**Re: Enbridge Gas Inc. (Enbridge Gas)
Ontario Energy Board (OEB) File No.: EB-2020-0192
London Line Replacement Project – Change Request No. 3**

CHANGE REQUEST

Project Name: London Lines Replacement Project

Change Request: 3

ADDED LAND REQUIREMENTS

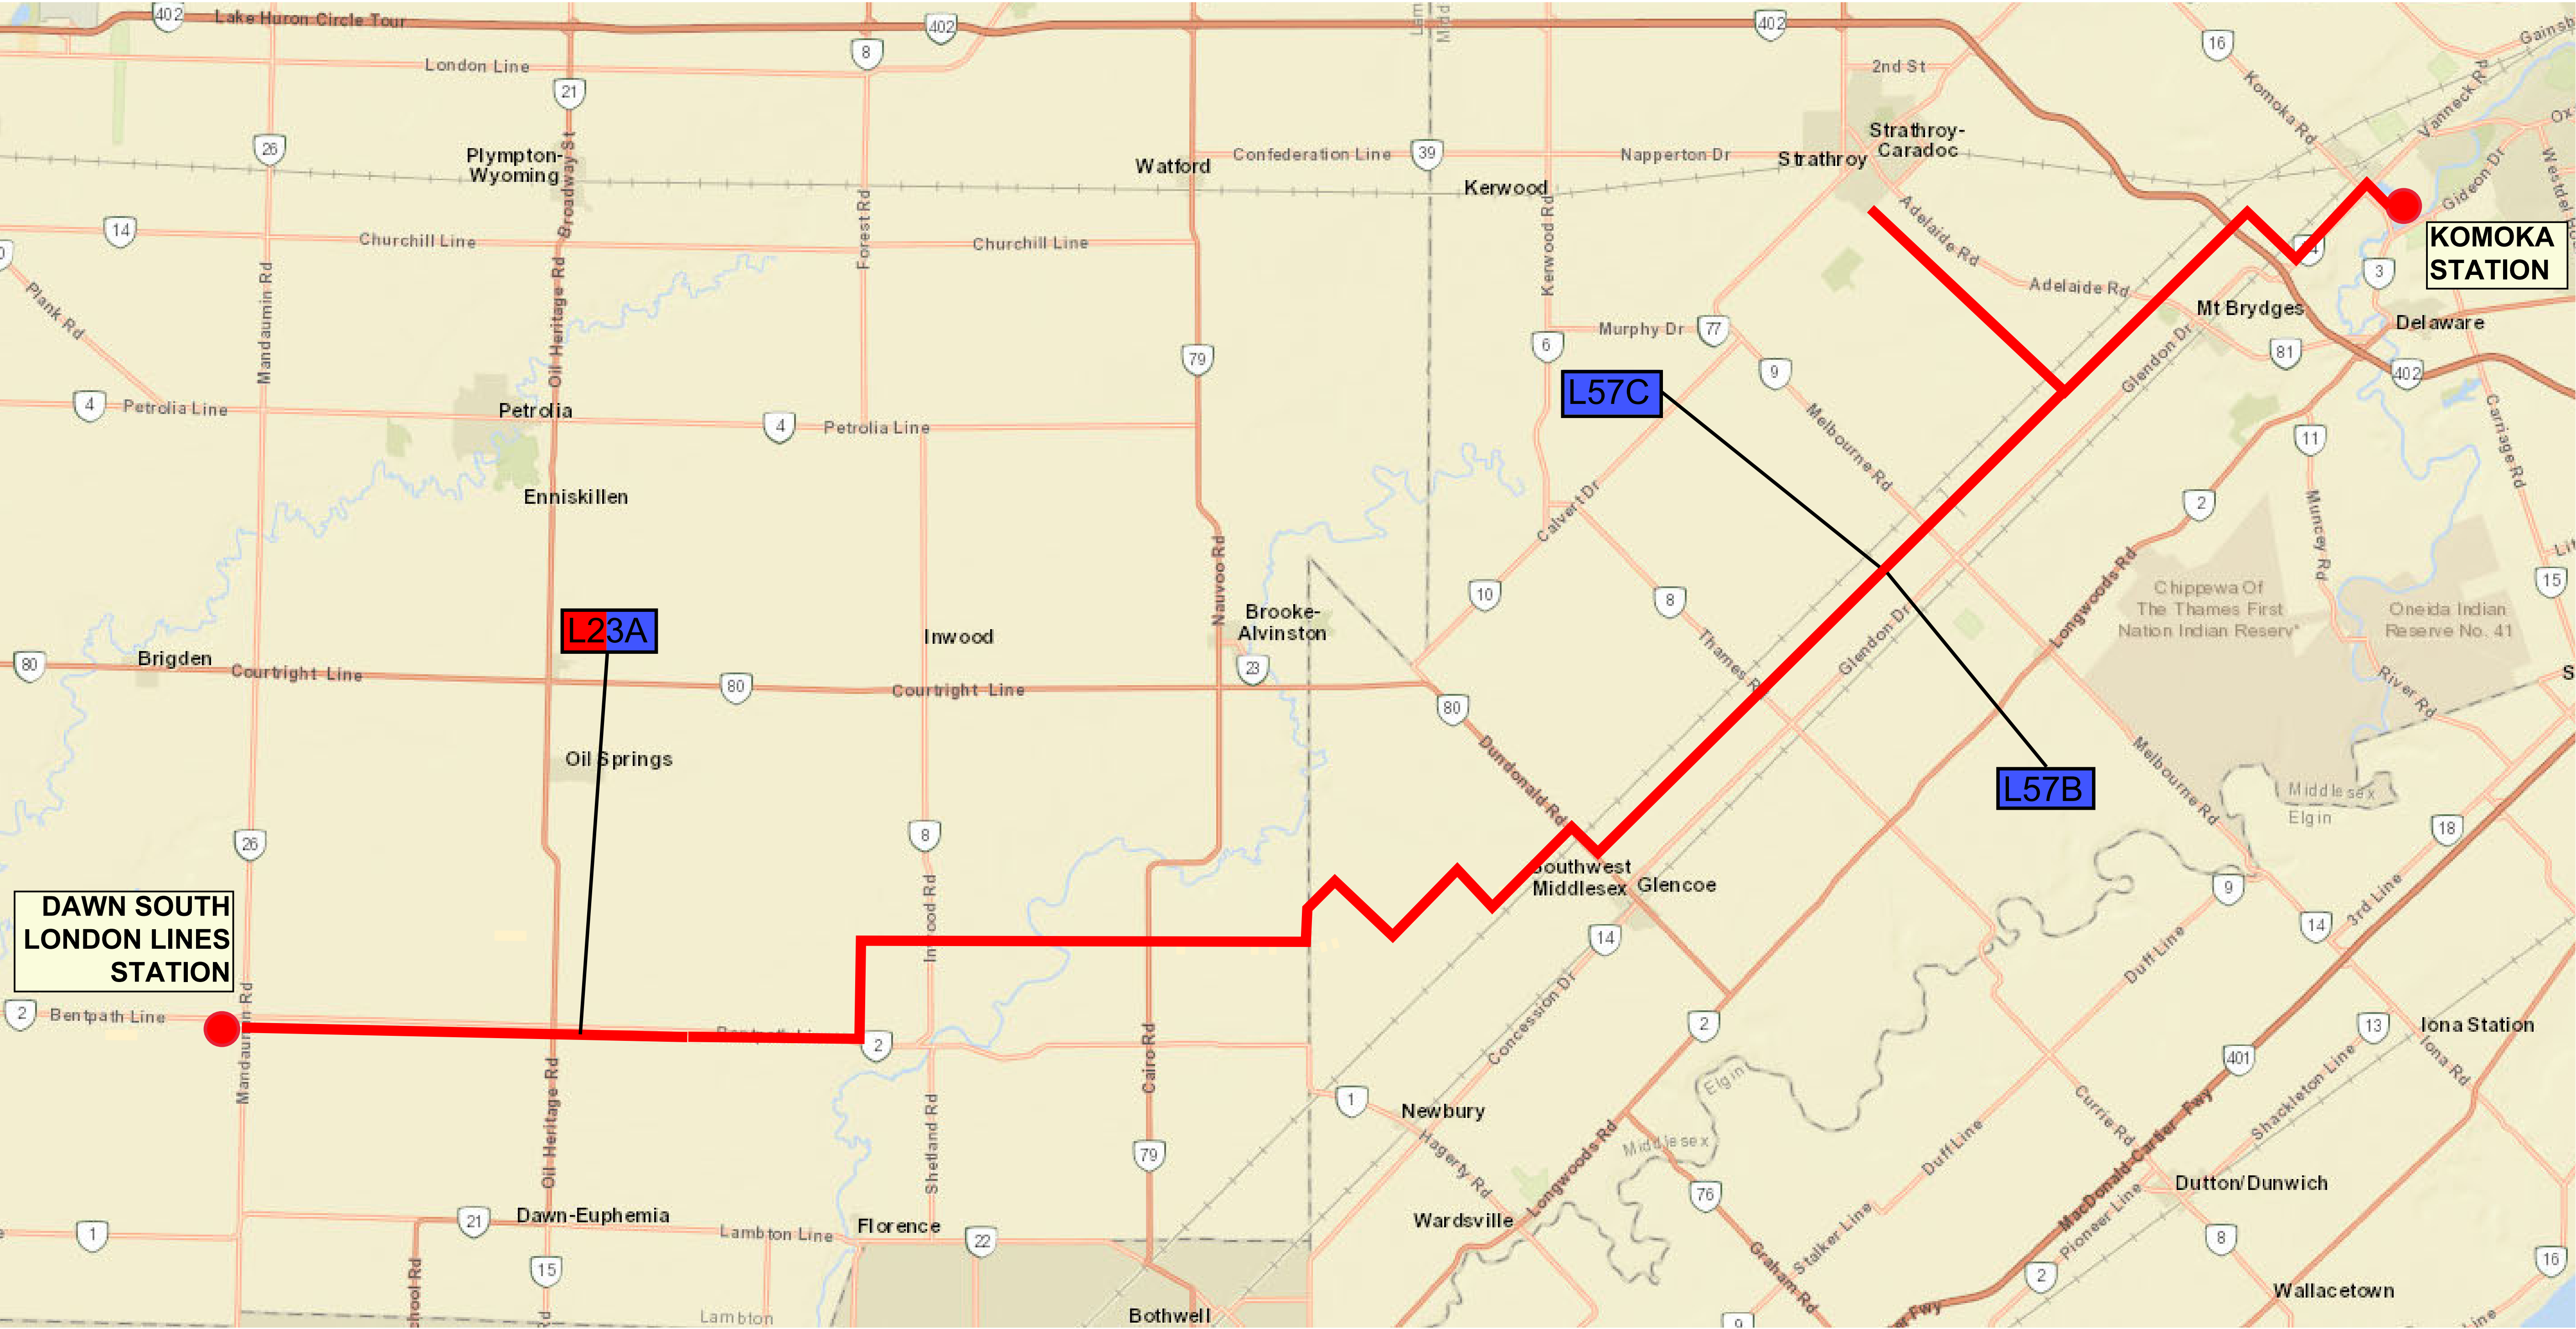
Enbridge Gas requires additional temporary land use rights (TLU) to allow for modified construction methods in several locations along the London Line Replacement Pipeline Project ("the Project") area. Recent detailed design work has identified areas where a road crossing should be shifted for safety and ease of installation, as a result TLU is required on L57B, L57C.

One additional land purchases have been identified for a station. Further detailed design work has shown that original location for the station was inadequate due constructability issues with other utilities in the area, as a result a piece of land is being purchased and TLU around that land has been requested (L23A).

SIZE	SHEET	DRAWING NO.
STRIP	48 OF 72

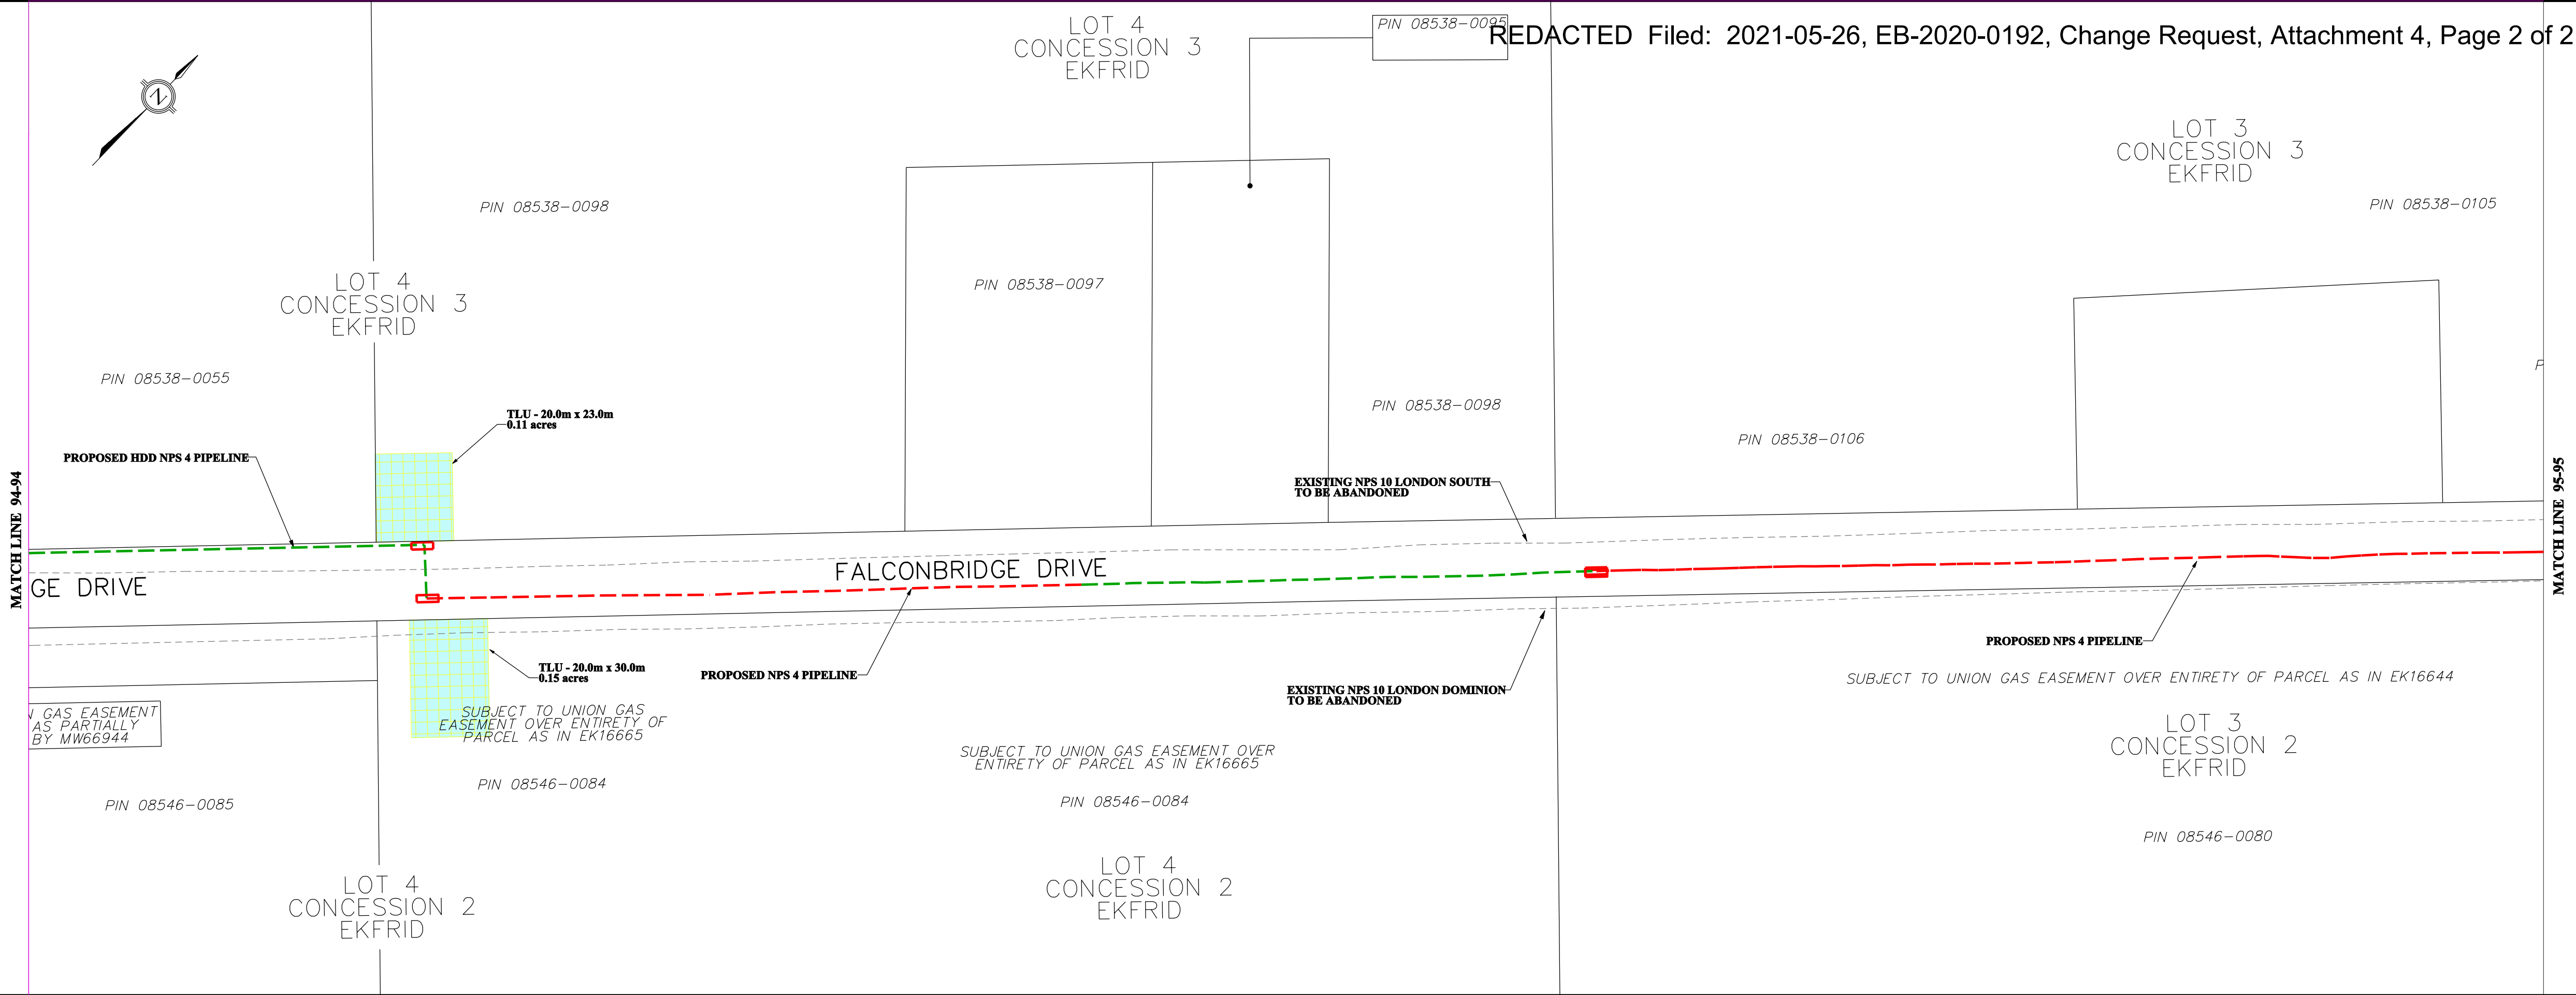
MW37848 AS PARTIALLY RELEASED BY MW54974 ; EKFRID				
L55B	08545-0057		PT LT 9, CON 2 IN MW90375, S/T IN EK16642 AS PARTIALLY SURRENDERED BY EK18431, S/T EK12615; SOUTHWEST MIDDLESEX TWP/EKFRID			8 x 15.0 0 012	
MAYFAIR ROAD							
L56	08538-0073		E 1/2 OF S 1/2 LT 8, CON 3; S/T INTEREST IF ANY EK36613 ; S/T MM715 EKFRID			30 x 30.0 0 090	
L57	08538-0066		PT LT 7, CON 3 , AS IN 911691 ; S/T MM716 EKFRID			30 x 30.0 0 090	
SPRINGFIELD ROAD							
L57A	08538-0055		W 1/2 OF S 1/2 LT 4, CON 3 EXCEPT EK6254; S/T MM722; MUNICIPALITY OF SOUTHWEST MIDDLESEX/EKFRID			20 x 30.0 0 060	
L57B	08538-0098		PART LOT 4, CONCESSION 3, EKFRID, AS IN MW102197 SAVE & EXCEPT PART 1, PLAN 33R-17523 AND PART 1, PLAN 33R-17951, S/T MM723 MUNICIPALITY OF SOUTHWEST MIDDLESEX			20 x 23.5 0 050	moved drill location further east
L57C	08546-0084		E 1/2 OF N 1/2 LT 4, CON 2; S/T EK14737,EK16665;EKFRID MUNICIPALITY OF SOUTHWEST MIDDLESEX			30 x 20.0 0 060	moved drill location further east
